## SERVICE BULLETIN NO. 406

TITLE COCKPIT OXYGEN PLUMBING REVISION

PURPOSE ALLEVIATE CONGESTED CONDITION  
BEHIND SIDE CONSOLE

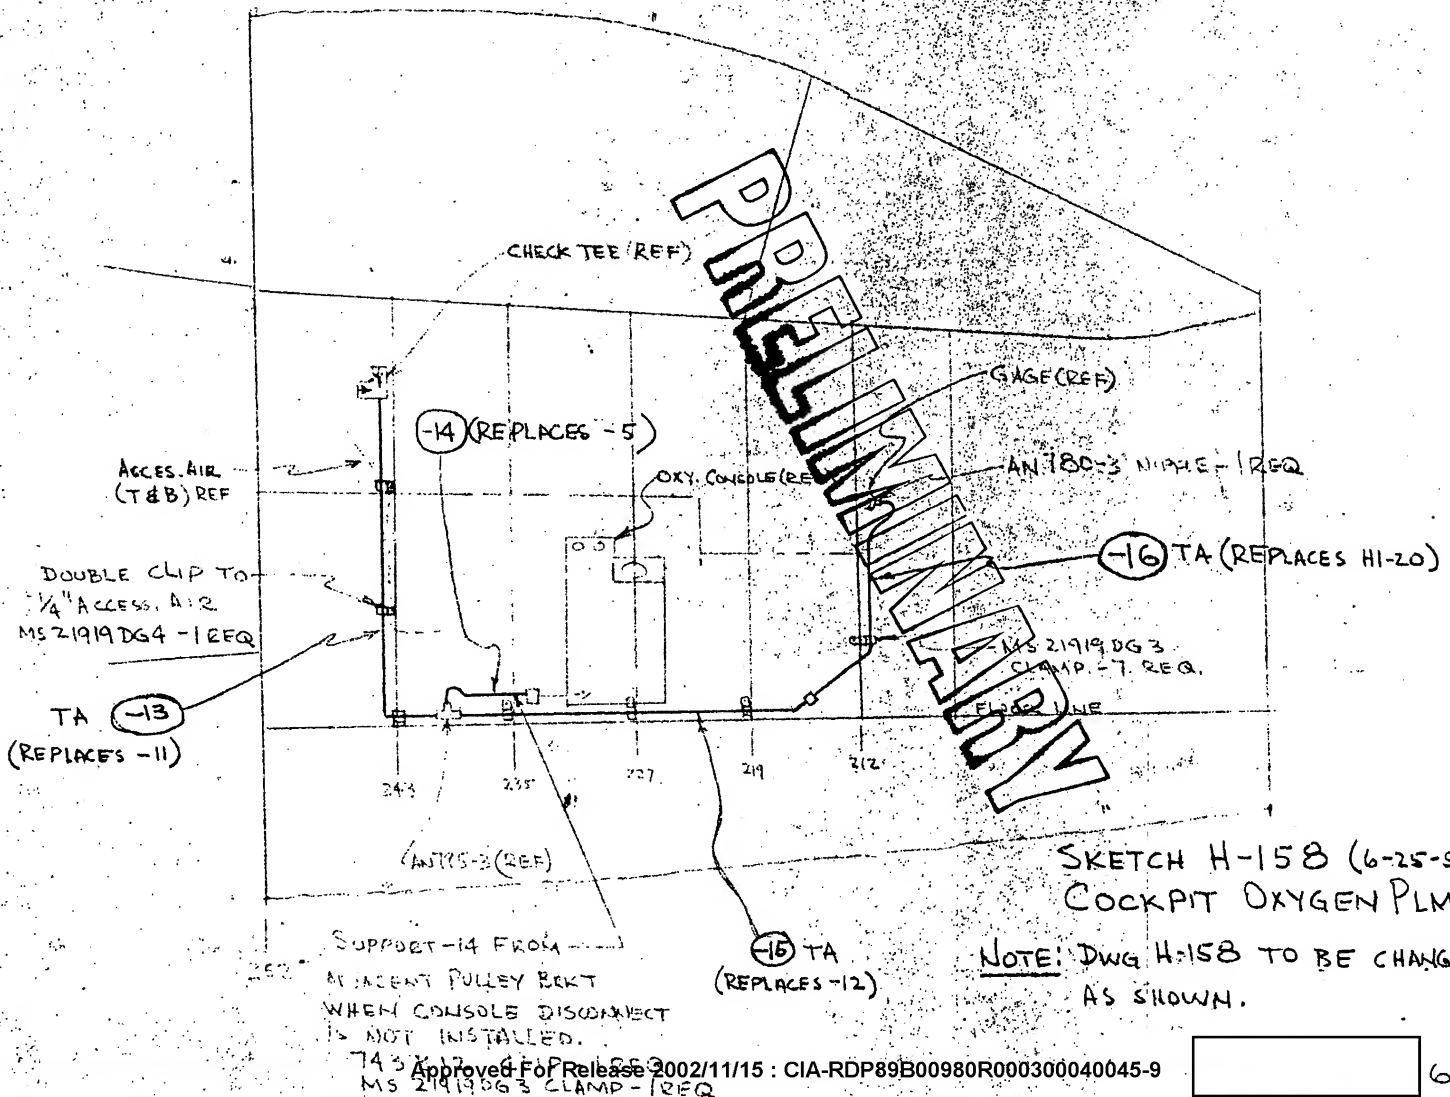
1. Remove H158-11, -12, -5 & H1-20 Tubes
2. Install H158-13, -14, -15, & -16 Per Ref. Dwg.
3. Replace existing fitting in pressure gage with AN780-3 Nipple
4. At 1800  $\pm$  100 psi, soap check all new & previously broken connections.  
No leakage allowed.

NOTE: Leakage at bottle connection may require new O-Ring (P/N WK 200573)
